WSRC-RP-2003-00362

Revision 2

ESTIMATED DURATION OF THE SUBSURFACE REDUCING ENVIRONMENT PRODUCED BY THE Z-AREA SALTSTONE DISPOSAL FACILITY (U)

11.0 APPENDIX C: DESIGN CHECK INSTRUCTIONS AND REVIEW

Figure 1. Conceptual Model (Vault is assumed to be cracked in half, i.e., the vault is twice the x-axis. Diagram represents one of the two equally sized vault fragments. Crack is located on the left edge above.)

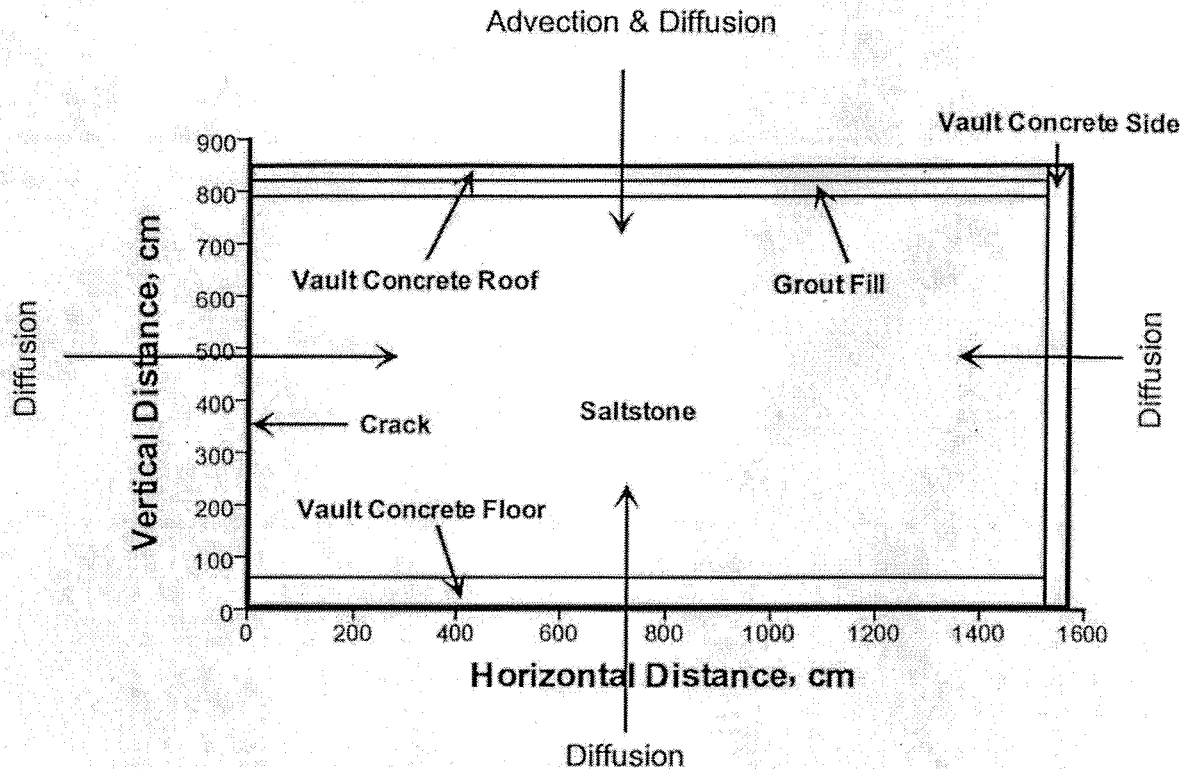
Conceptual Model section: I would say more explicitly that the left side of the conceptual model assumes a crack that extends fully from the top of the Saltstone monolith to the bottom and which allows movement of water along the full length.

3. Figure 1: in diagram make location of crack evident.
4. Error bars on Figure 3 are inconsistent.
5. Table 4. a) rather than *Calculations for Estimating Oxidation capacity of Salt Solution...* I would suggest Estimation of Oxidation Capacity of Salt Solution based on Oxidizing Constituents (or ingredients). Should be "Used in equation 2" not equation 3. Footnote b) should read $1E-04 \text{ molesL}^{-1}$).

Figure 4. Simulation Result at 250,000 Years (Units in meq e⁻/g_{solid}). Red Indicates no Oxidation of Saltstone Occurred and Blue Indicates that Full Oxidation of the Saltstone Occurred.

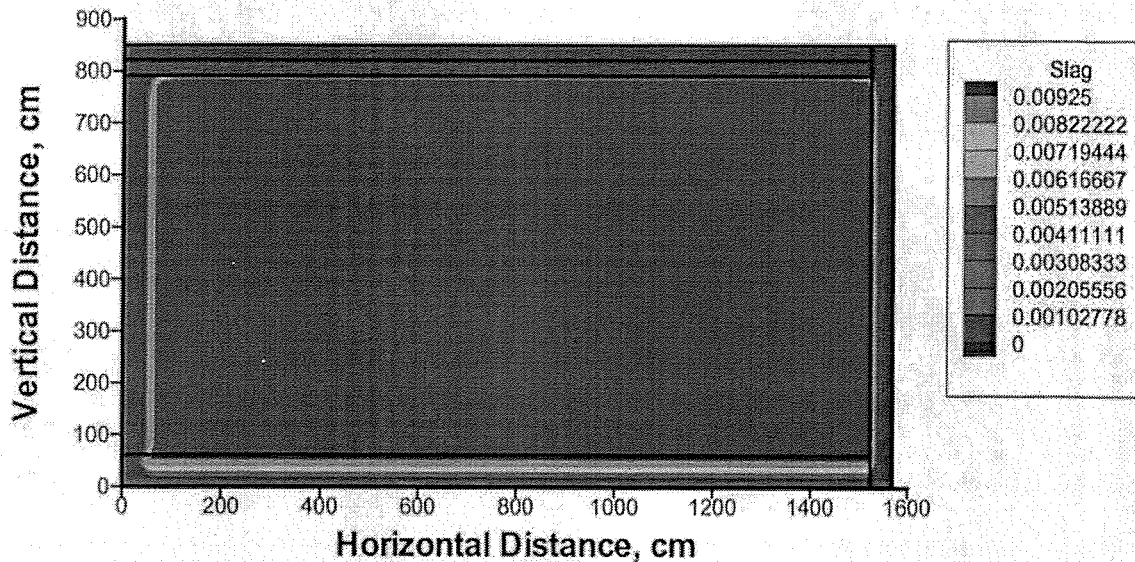
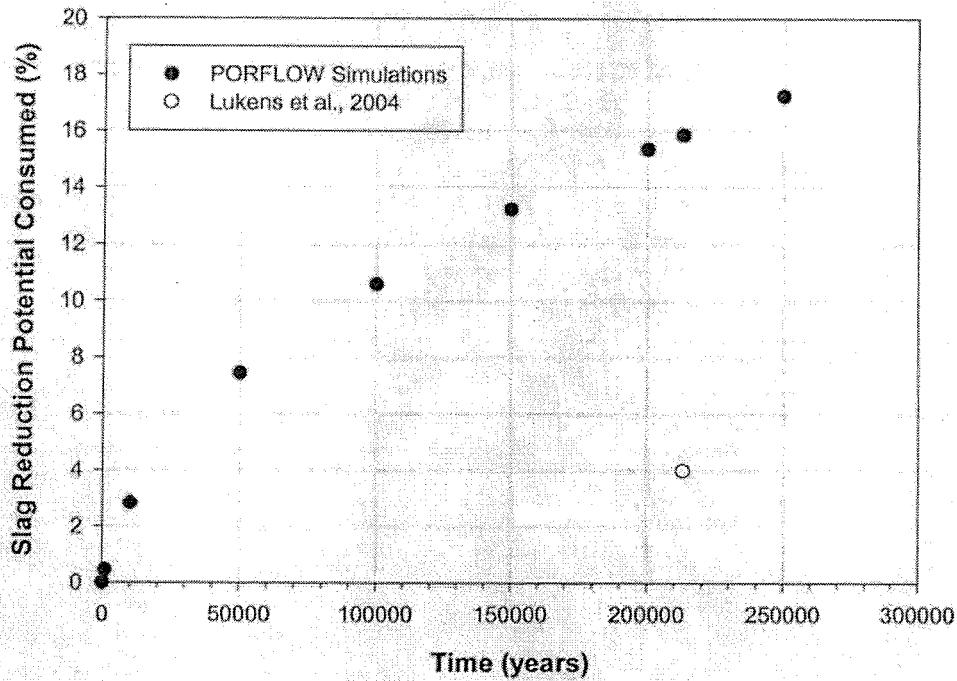
- 3b. Figures 4 and 5 were spot checked using Porflow output for 50,000, 150,000 and 250,000 years. The same values were obtained for the percentage of species C2 (slag) consumed at these times as is shown in Figure 4. Using output for the same years to evaluate the depth of slag oxidation on the left face at $J=33$, the same values for depth of penetration were obtained as is shown in Figure 5. The graphs accurately reflect the results obtained from model simulation.
